TN and TP Hub ABS Tone Ring Mounting

HDNABI® is implementing a product improvement on Hubs with current ABS Tone Ring Mounting for TN and TP trailer applications. The current ABS Tone Ring Mounting will be replaced by a new reinforced Mounting design that increased Breakout force over 3.4 times compared with current mounting.

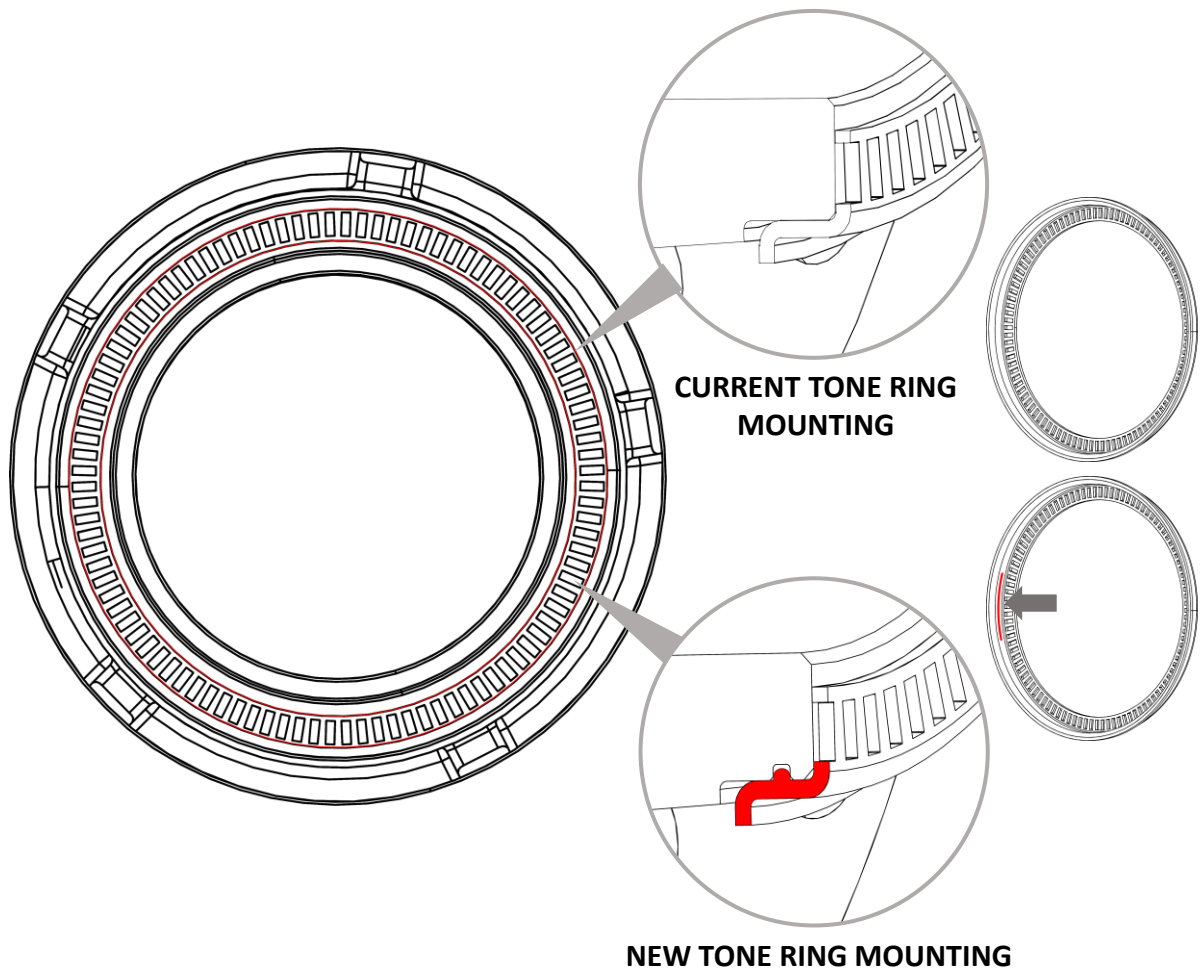
This change requires new part numbers assigned to the Hub as well as the Hub & Rotor assemblies with separate “Part Number Update Announcement” will be available soon. The improve design will be available for productions beginning 2nd quarter of 2021.
